Interactive comment on "Tsunami evacuation plans for future megathrust earthquakes in Padang, Indonesia considering stochastic earthquake scenarios" *by* Ario Muhammad et al.

We appreciate Reviewer 1 for his/her positive and constructive comments on the submitted manuscript. The following are our point-by-point responses to the reviewer's comments.

Fig. 1. Tsunami wave height profile near coastal line of Padang: (A) site location. (B). Tabing (P1) station). (C). Purus (P2) station.

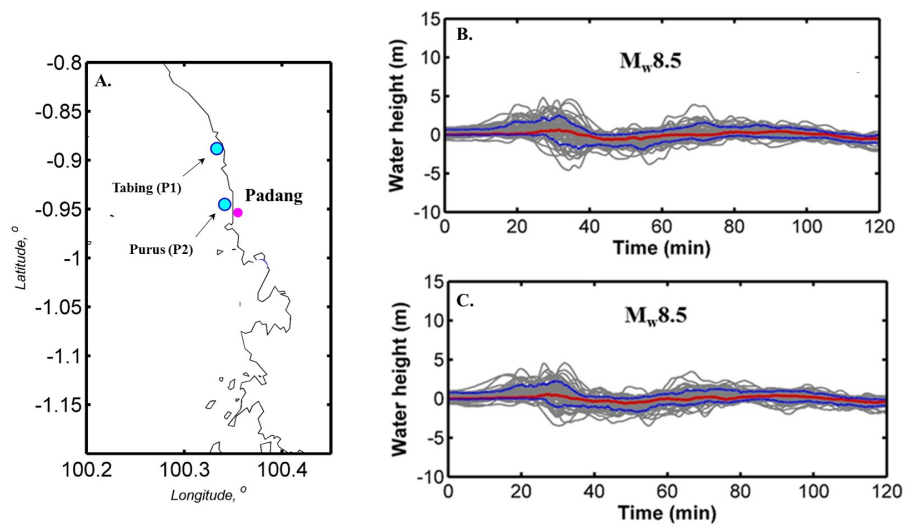
C2 - EARTHQUAKE SCENARIO SELECTION: The authors must justify their choice as regards the magnitudes of the earthquake scenarios. Why a minimum Magnitude of 8.5 and not 8.25, for instance? Is a Mw8.25 earthquake causes a tsunami with no significant effect on the study area? Why do the authors not consider a maximum earthquake magnitude in the range of this of the 2004 Indian Ocean event (Mw9.2)? Such a choice would change the predicted tsunami inundation characteristics and therefore the associated evacuation plan.

We used Mw 8.5 as the minimum scenario magnitude in our study because the tsunami hazard produced from the magnitudes less than this level, e.g. Mw 8.25 and Mw 8.0, are considered to be relatively small (below 1 m wave height in the coastal areas; McCloskey et al., 2008; Muhammad et al., 2016). From Figure 1 in this document, we see the relatively minor effects in Padang due to Mw 8.5 tsunami . It shows the tsunami wave heights at three stations, i.e. Tabing, Purus, and Teluk Bayur, at a depth of 5 m. The median wave heights produced from 100 tsunamigenic scenarios are about 1 m which is small and will have minor impact on land (see Muhammad et al., 2016). The impact becomes more insignificant if we consider the Mw 8.25 scenario. Therefore, we choose the Mw 8.5 as the minimum magnitude scenarios.
